Addison Circle Valet Drop-off Addition

DRAWING TITLE:
Valet Drop-off Area

PROJ. No: 06-679
PHASE: C.D.
DATE: 2.FEB 2006
DRAWING NUMBER: **A1**

01 VALET DROP-OFF AREA
SCALE: 1/4" = 1'-0"

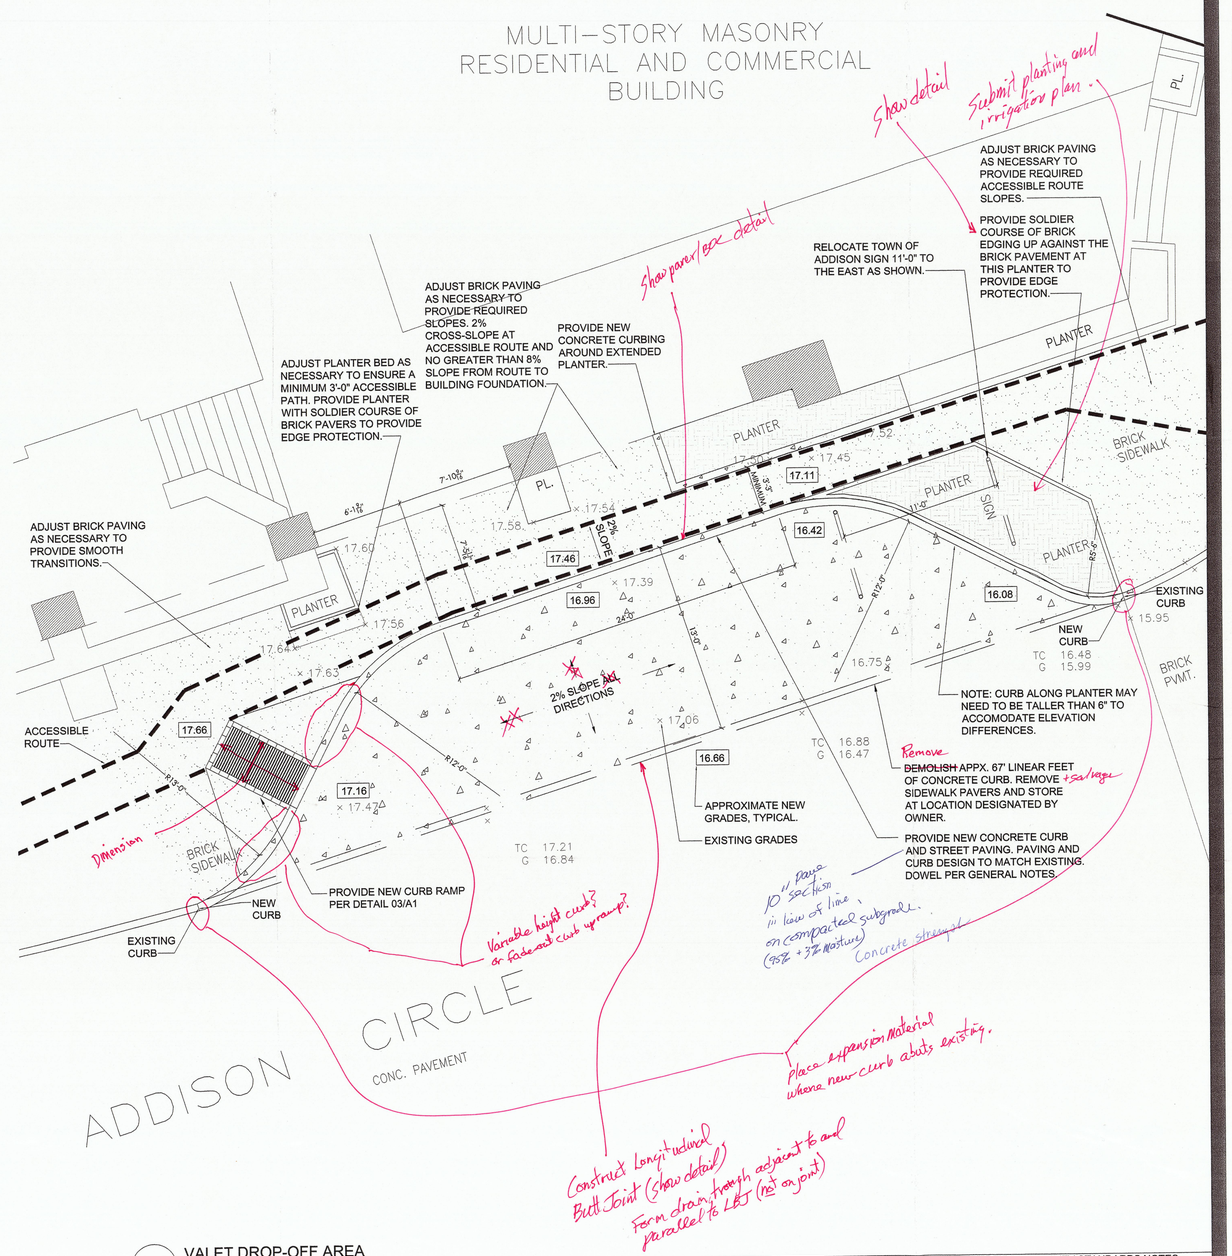
7. MAXIMUM SLOPE AND CROSS-SLOPE OF HANDICAPPED ACCESSIBLE PARKING SPACES AND ADJACENT ACCESS ISLE IS 1:50 (2%) IN ANY DIRECTION.
8. ALL NEW CONCRETE SHALL BE DOWELED INTO EXISTING CONCRETE @ 12" O.C. WITH 18" ~~NO.3 DEFORMED BARS.~~ #5 smooth dowels spaced 9" into existing, perpendicular to face of concrete. ALL NEW SIDEWALK or paver base CONCRETE SHALL BE CONSTRUCTED OF 4" THICK 4000 PSI CONCRETE WITH NO. 3 BARS @ 12" O.C. OVER 1" SAND BEDDING COURSE. ENSURE 2" CONCRETE COVERAGE ON ALL STEEL BARS, TYPICAL.
